September 26, 2012

Serial No. 12-615
SPS LIC/CGL R1
Docket Nos. 50-280/281
License Nos. DPR-32/37

VIRGINIA ELECTRIC AND POWER COMPANY
SURRY POWER STATION UNITS 1 AND 2
PROPOSED LICENSE AMENDMENT REQUEST REGARDING
TEMPORARY SERVICE WATER JUMPER TO THE
COMPONENT COOLING HEAT EXCHANGERS

Figure 1 – Temporary SW Jumper to CCHXs Configuration

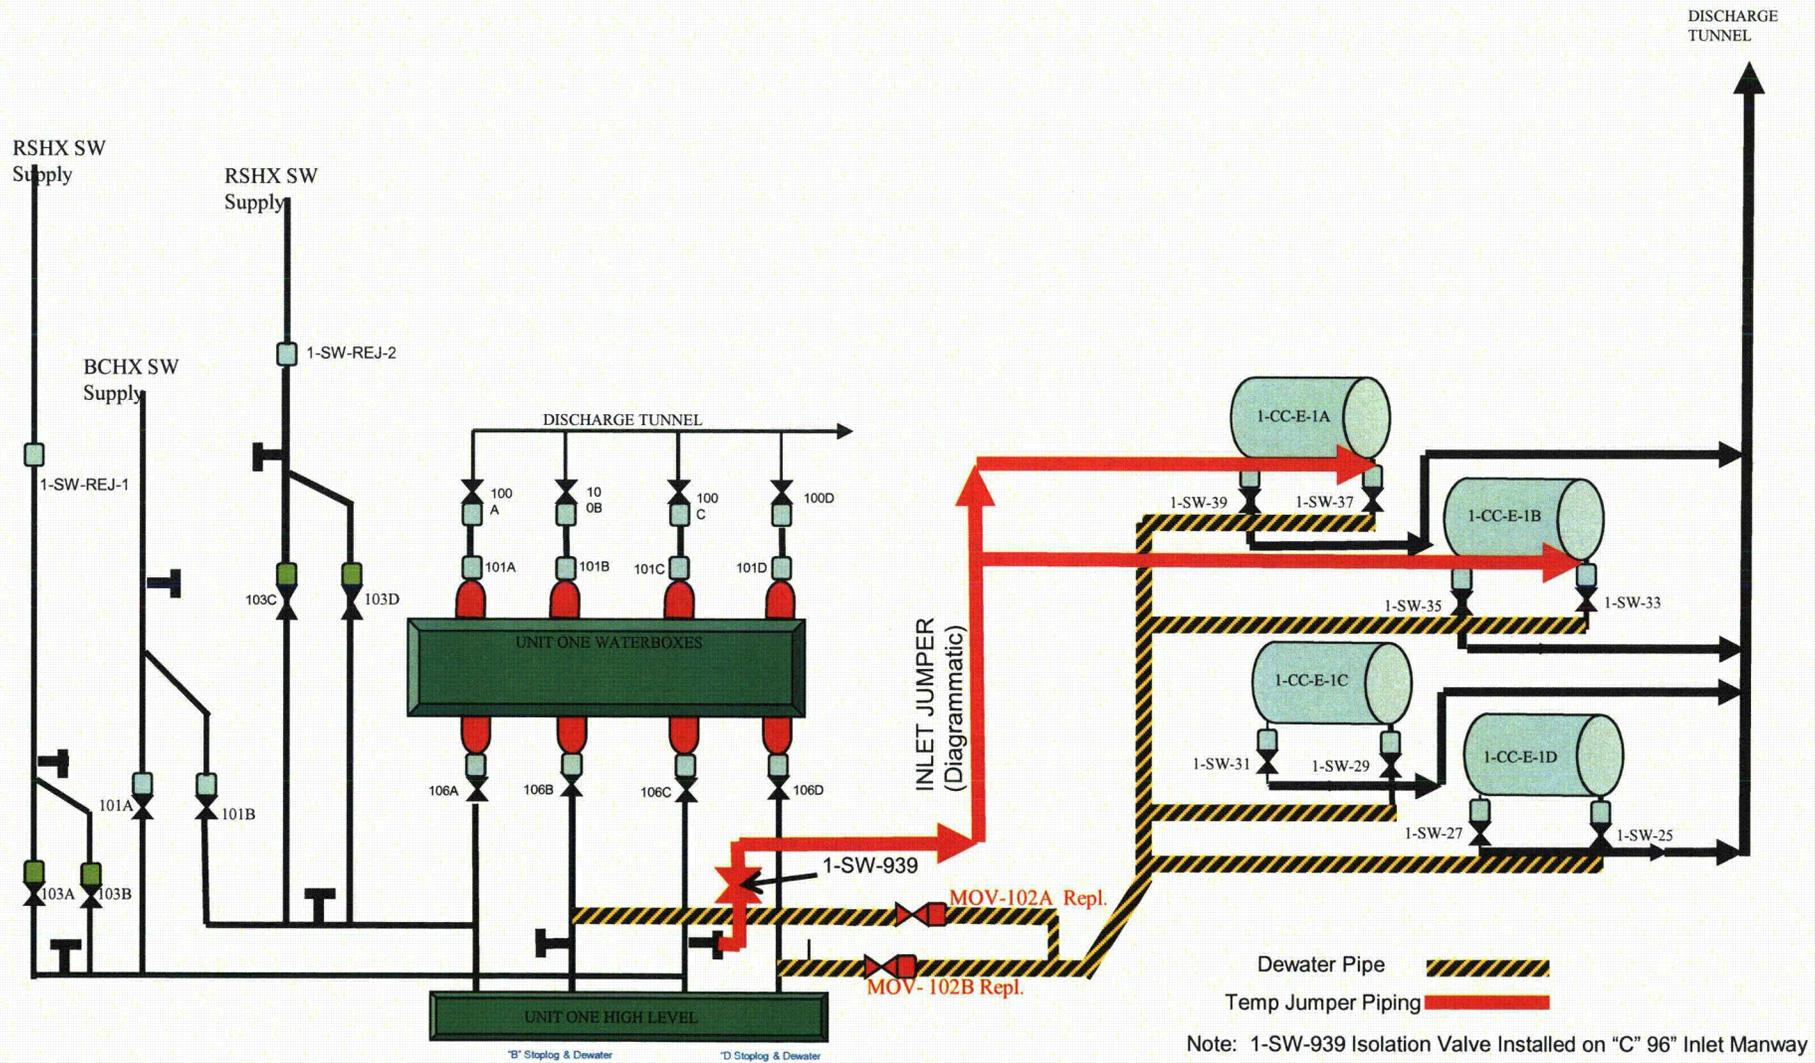
The general sequence of activities for the project is as follows (Figure 1):

- 1) Install the SW jumper from the "C" Circulating Water (CW) supply piping to the "A" and "B" CCHX inlets.
- 2) Remove "A" and "B" CCHXs from service. Remove the CCHX inlet expansion joints at valves 1-SW-37 and 1-SW-33 and blank the piping at the valve outlets/CCHX inlets to isolate the "A" and "B" CCHXs from the normal SW supply.
- 3) Place the jumper in service.
- 4) Stop log, blank, and de-water "B" and "D" inlet bays and 96-inch CW piping. Drain the SW piping to be cleaned, inspected, repaired, and recoated.

The temporary SW jumper is a seismic, safety-related pipe, which will be installed from the Unit 1 "C" 96-inch CW inlet piping manway to the inlet piping of the "A" and "B" CCHXs (Figure 1). The piping is uncoated, 30-inch carbon steel, standard wall pipe. The jumper configuration is flanged with butterfly valves at the inlet (1-SW-939) and at the "A" and "B" CCHXs supply connections. The design pressure and temperature ranges for this piping are 25 psig (10 to 15 psig, normal) and 32°F to 80°F, respectively. The line is sized to deliver adequate cooling water flow to two CCHXs to remove design basis heat loads. The jumper will be in service during times of the year when SW supply temperatures are at or below 80°F to provide additional margin for heat transfer capability under tubesheet fouling conditions. Use of the jumper with SW supply temperature greater than 80°F is not permitted.

Figure 2 – Temporary SW Jumper Routing
(Turbine Area – Ground Floor – Unit 1)

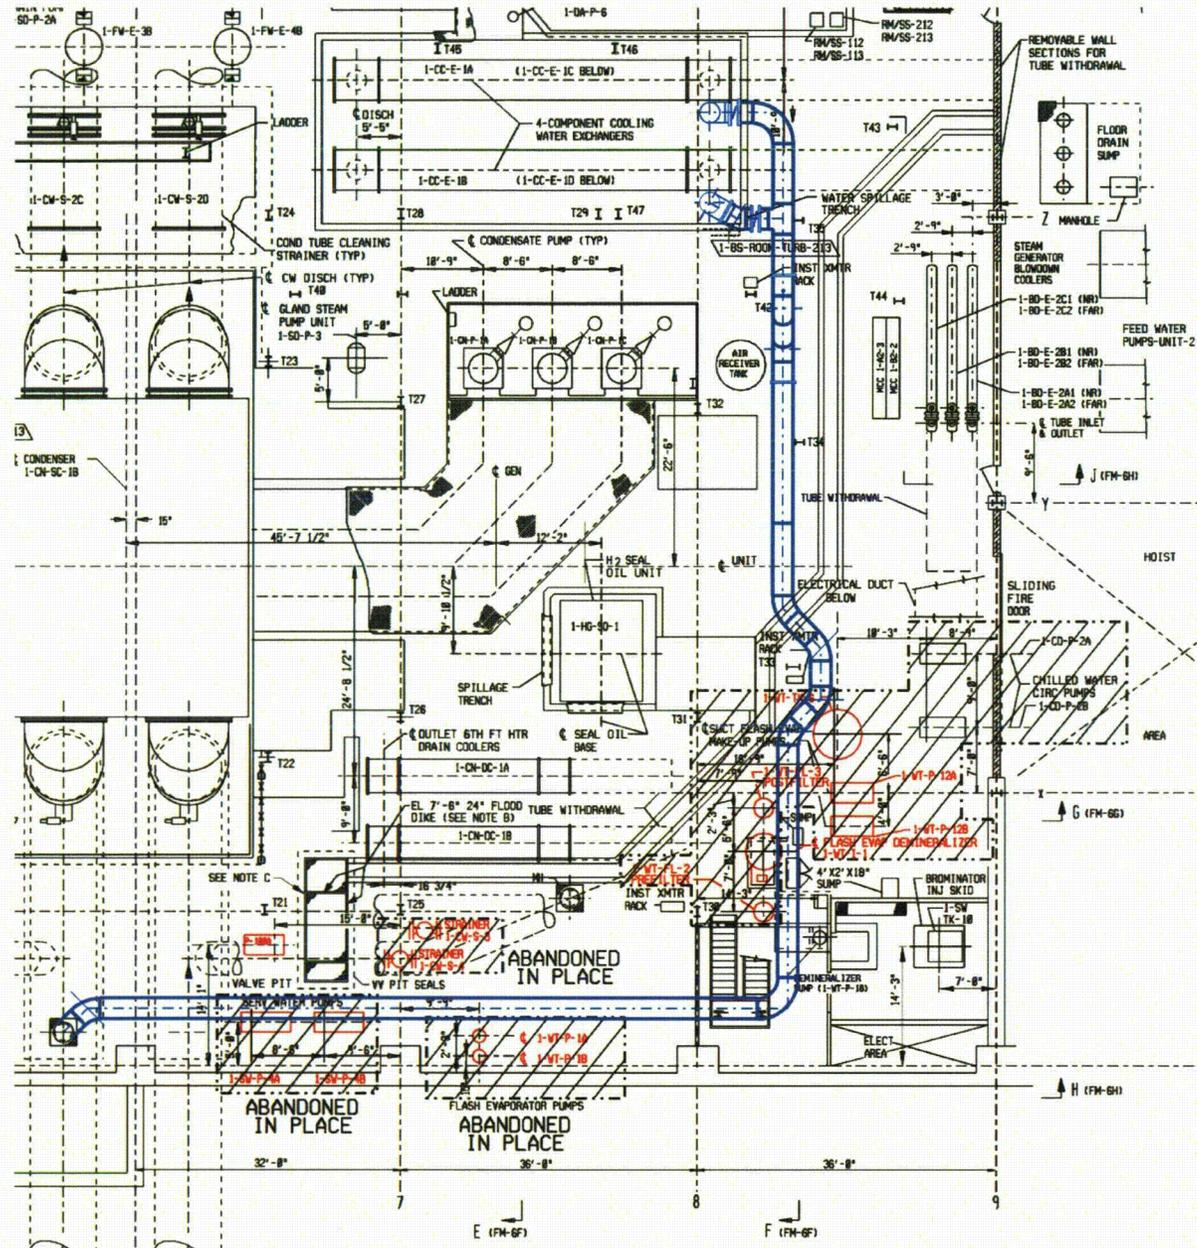
The total length of the jumper is approximately 223 feet, with 44 feet or 20% of the total run protected by the CCHX missile shield from a vertical utility pole missile strike. The operating floor at Elevation 58'-6" is a 9" thick reinforced concrete slab supported by steel framing. This will provide missile protection for approximately 148 feet or 66% of the total run from a vertical utility pole missile. The remaining 31 feet, or 14% of the jumper, are not protected by either the turbine floor or any other missile protection. However, there are energy absorbing interferences in the way of a direct missile hit such as steel grating, structural steel, piping, and other equipment. The elevation of the jumper is well below outside finished grade and would present a relatively small target to a missile that would have to pass through these interferences.
